**CITY OF TEMPE
DEVELOPMENT REVIEW COMMISSION**

**Meeting Date: 12/10/2019
Agenda Item: 12**

ACTION: Request a Use Permit to allow a drive-through in the CSS zoning district and a Development Plan Review for a new 1,903 s.f. restaurant for **DEL TACO**, located at 1331 North Scottsdale Road. The applicant is Sender Associates, LLC.

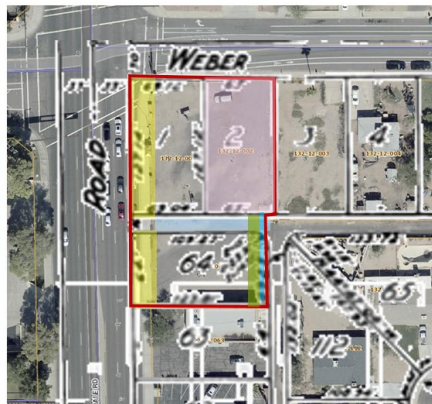
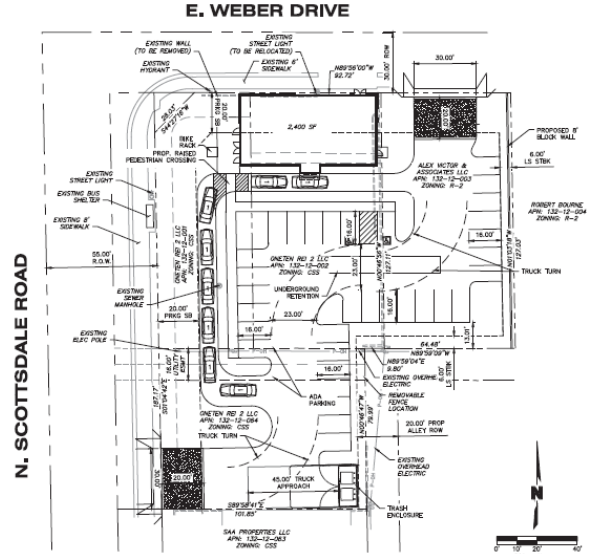
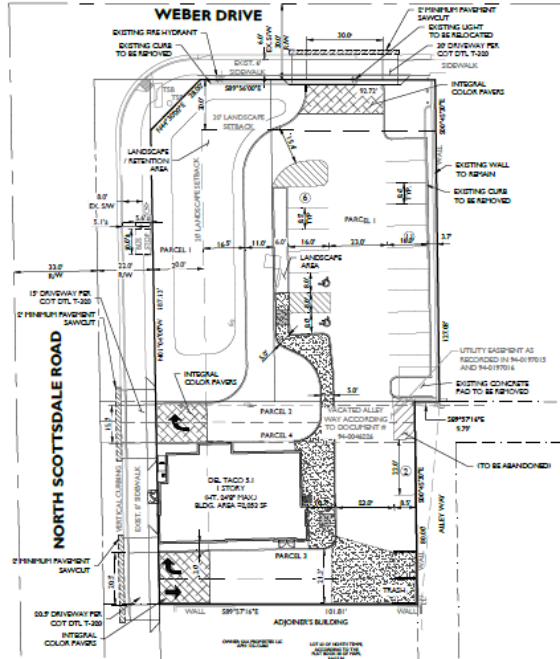
The first Preliminary Site Plan Review was August 30, 2017. The building was located on the north east corner of the lot, on Lot 2, with the drive through adjacent to the residential lot to the east. The site plan as proposed did not meet multiple code requirements, including quantity of parking, required site circulation for refuse access, required landscape islands. Staff requested verification of the site size, letter of explanation said .51, site plan said .91, and the property line dimensions on the plan were not accurate. The 2,400 s.f. building required 32 parking spaces but only 25 were provided. Staff recommended shifting the building to the south west corner, away from the residential properties, adding a patio, relocating refuse away from the street front and reducing the size of the building to meet parking requirements. Elevation recommendations were to incorporate arch elements similar to other buildings of this tenant for an enhancement to the architectural form (examples of other restaurant sites were provided). Staff recommended use of masonry on all four sides to break up the stucco. It was determined that the alley was substandard and required an additional 4' of right of way to provide a 20' alley width. Lot 64 was adjacent to a single-family residential district and therefore required a minimum 6' landscape buffer with trees. Due to the narrow depth of the lot however, the required landscape buffer and additional 2' of easement affected the parking on the south side of the site and along the eastern property line adjacent to the alley. The code landscape requirement also required landscape islands, which would impact potential availability of additional parking spaces. The combined challenges to the site design included the following:

Prior:
ROW
dedications

Prior:
Alley
abandoned
Public Utility
Easement
added
(No trees or
structures
allowed in
PUE)

Private Deed Restriction on Lot 2
(Not enforced by City)

Required:
2' Alley easement added

6' Landscape buffer required

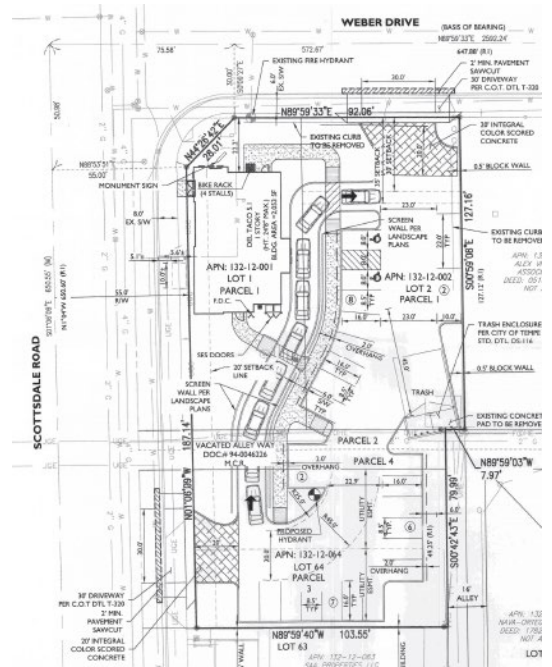
The second Preliminary Site Plan Review was November 1, 2017. The site now included the vacant lot to the east and moved the building to the Weber street front on Lot 2, with the driveway and parking located on Lot 3 to the east. The building was 2,400 s.f. and provided 33 parking spaces. Refuse was still facing the street and required the collection truck to back up into incoming traffic; this solution did not meet safe circulation requirements. The 4' alley right of way dedication required on Lot 64 from traffic engineering and solid waste services had not been addressed. Staff recommended shifting the building south slightly to allow room for landscape along the street front. Staff recommended incorporation of a patio at the north west corner. The south property line was dimensioned as 101.81'.

The third Preliminary Site Plan Review was July 31, 2019, almost 2 years from the first submittal, and with a new design team. The site no longer included Lot 3 to the east. A third and new site plan was proposed, with the building in the south west corner of the site along Scottsdale Road, with two drives on Scottsdale and a third on Weber. The site did not meet traffic engineering, building safety or planning requirements. The building size reduced to 2,053, requiring 27 parking spaces, but only 19 were provided. The driveways on Scottsdale were a primary issue. Prior comments regarding the 4' alley ROW dedication and 6' landscape buffer adjacent to single family had not yet been addressed, and the site retention was predominantly in the street frontage. Refuse location still required trucks to back up into the traffic entering the site. The proposed layout did not provide enough parking, nor did it have a patio. The south property line was dimensioned as 101.85'.

The fourth Preliminary Site Plan Review was August 28, 2019. The building was relocated to the north west corner of the site, with one drive on each street, refuse moved back to the location that it had been during the 30 years that the prior Jack-in-the-Box had occupied the site. The location was very similar to the originally constructed restaurant on this site, but with less land area. Aerial research showed the refuse enclosure on site in the same location up to 2007 when it was torn down 15 years after the restaurant. The building size was 2,053, and 25 parking spaces were provided but the drive aisle width did not meet standards. Staff suggested reducing the building size to 1,650 with a 360 s.f. patio to meet the available 22 spaces of parking on site. Staff suggested that some of the building footprint of the structure could be under roof but no walls, to create the patio without changing the corporate building footprint. The 4' alley ROW dedication and 6' landscape buffer had not yet been addressed, and these two items would remove 10' of parking area on the east side. There were design comments provided regarding the landscape plan. The south property line was shown as 101.81'.

Staff met with the applicant to discuss the requirement of the 4' right of way requirement in the alley. It was determined that an easement would be supportable rather than a right of way dedication, as long as the intent was to build the site wall to accommodate the additional alley width. It was later determined that the 4' requirement to make a 20' alley, would be typically split between both sides of the alley, not requiring one side to give the full 4'. Therefore, traffic engineering staff and solid waste staff agreed to allow a 2' alley easement along the east side of Lot 64 to accommodate additional maneuvering room in the alley. The easement would meet the intent by widening half of the alley and was critical at the intersection of two alleys where trucks are required to turn. As future adjacent lots redevelop, additional ROW would be required to make the full 20' alley.

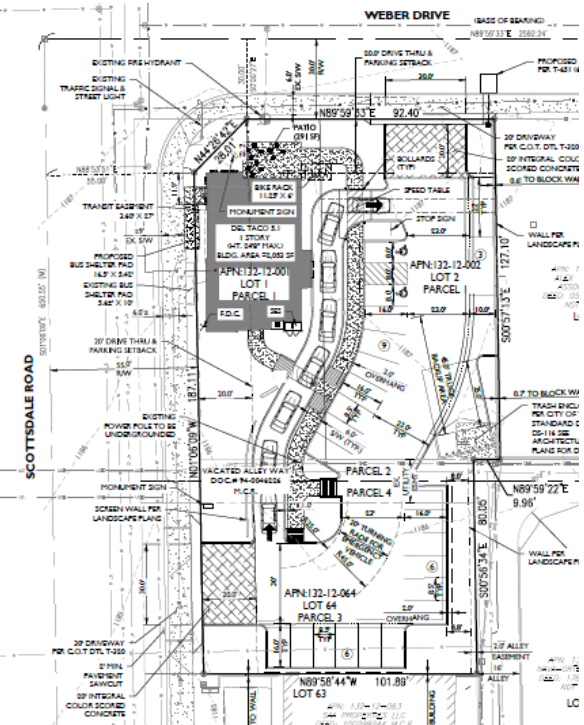
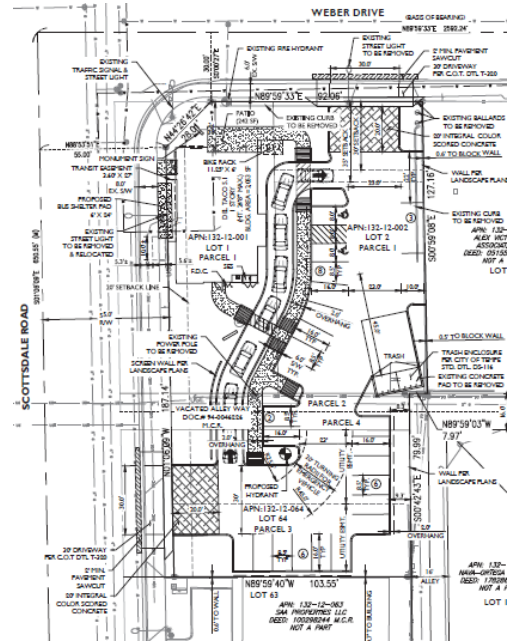
The fifth Preliminary Site Plan Review was September 25, 2019. Most of the comments regarding design were addressed. The south property line was shown as 103.55'; engineering staff asked for clarification why this number had changed. This inquiry required consultation with survey staff in another department. The refuse container was also encroaching within a corner of the public utility easement and needed to shift north. A new street light was needed on Weber Drive. The proposed primary building material was a cast faux brick that was paintable, staff advised that this did not meet expectations for a quality material and provided no variation between grout lines and masonry. Recommendations were made to modify the wainscot to a more contemporary cut stone or block rather than rustic stacked stone. Questions and comments on landscape plan were minor. While most other issues were being resolved and details worked through, the parking still did not meet code, and discussions continued regarding the option to reduce the building size or the need to apply for a variance.

The first Formal Review was October 23, 2019. The preliminary utilities plan did not have the trees screened in for review for conflicts. The lighting plan did not provide sufficient information to review lighting design, but comments were made to minimize illumination on the east side facing the neighborhood and not over-light the site. Recommendations were made on the location of the lights on the building. Staff recommended that the trellis canopy be modified to provide shelter over doors and the drive-through window. The transit easement was proposed to change locations further north, which conflicted with the dining room window area, staff required that the easement be shifted back to the current location south of the existing street light, to provide surveillance to and from the dining room. Landscape islands were missing in one location. Screen walls for parking and circulation were missing from plan. Notes regarding wall details were missing. Most other comments were formatting related. The building elevations were modified to use a different masonry product to meet staff recommendations. The building size was 2,053 s.f., with a 291 s.f. patio with 27 parking spaces required and only 24 available on site. The south property line was revised to 101.89'.

On November 4, 2019, revisions to the formal submittal were made. All staff comments regarding the site plan, landscape plan, elevations and lighting were addressed, and canopies were modified to provide shelter over doors and drive through window.
